Team Update 01

Team updates notify the *FIRST* Robotics Competition community of content changes to any official season documentation (e.g. the game and season manual, award deadlines, drawing changes, etc.) or important season news. Team Updates will not highlight typo fixes.

Figure 3-7: AIRSHIP elements

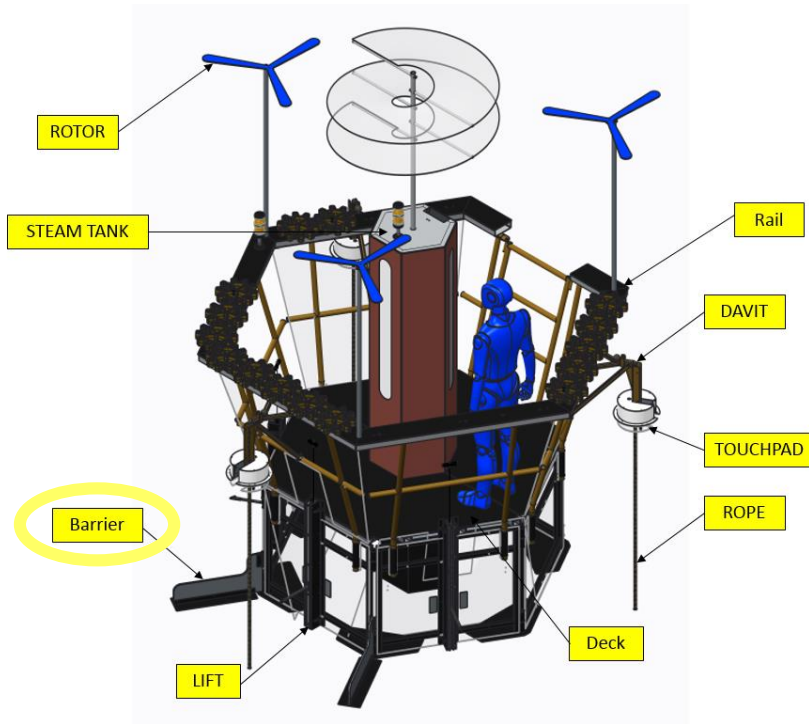
Figure 3-7: “Divider” label has been changed to “Barrier” to match text in Section 3.5 LIFTS.

Figure 3-24: ALLIANCE WALL COMPONENTS

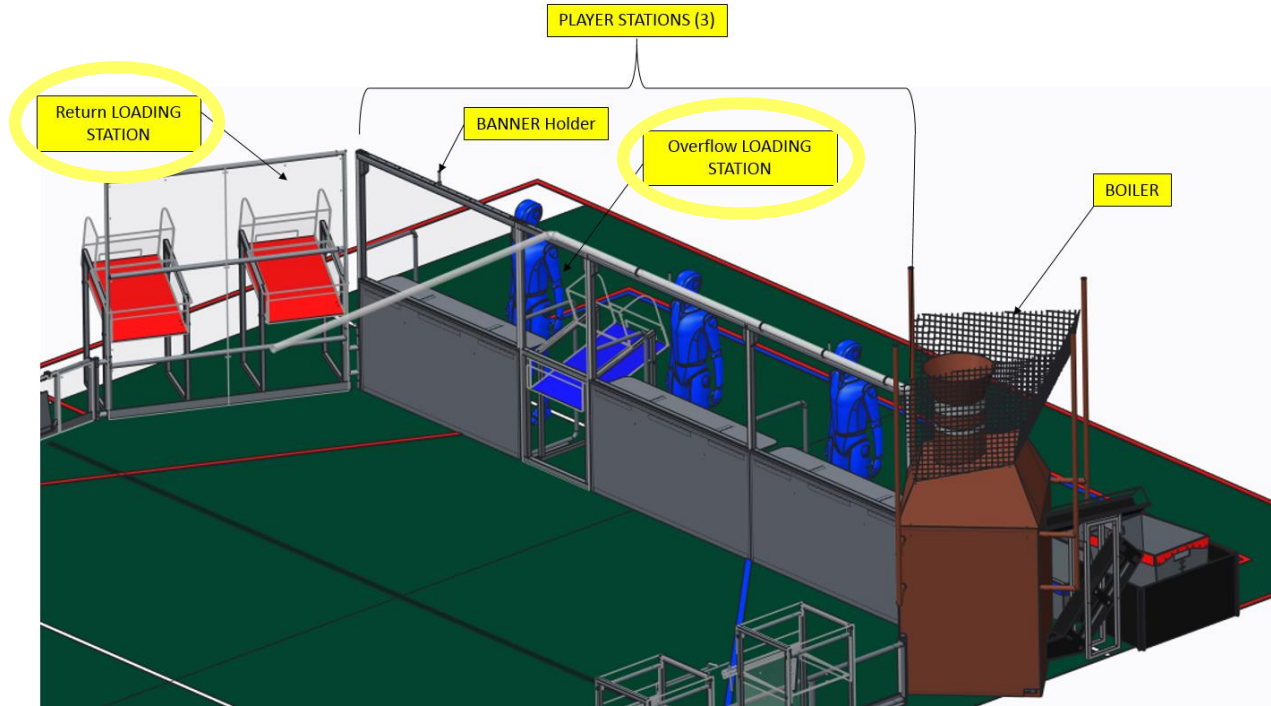
Figure 3-24: The labels for the OVERFLOW and RETURN LOADING STATIONS have been corrected.
